**REQUEST TO CHANGE PEET FLAGSTONE PDA DEVELOPMENT APPROVAL
SECTION 99 OF ED ACT – FLAGSTONE CITY: CA3 SOUTH (DEV2024/1491/3)**

It is proposed to make minor amendments to the latest approval package issued by EDQ on 16 June 2026, pursuant to Section 99 of the *Economic Development Act 2012* (the Act).

Table 1 – 10.5m wide 25m deep Villa Lot retaining wall comparison

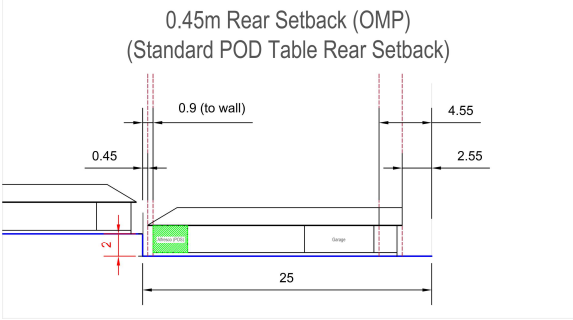
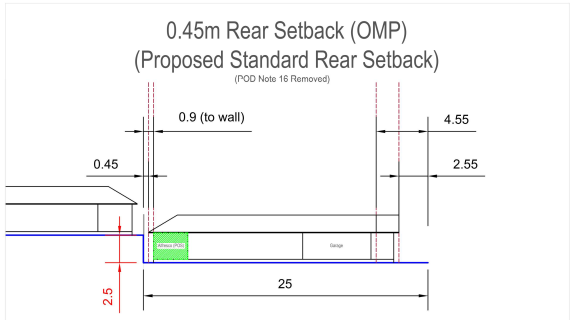
- 20 lots in Stage 10; and
 - 29 lots in Stage 12.
- In a scenario where POD Note 16 is no longer applicable to 25m deep lots, there is little difference between solar access for 25m deep lots when rear retaining walls are 2m versus 2.5m in height. Refer to **Table 1** below and **Attachment D – Cross Section Comparison – 25m Deep Lot** for further detail.

2m rear retaining wall	2.5m rear retaining wall
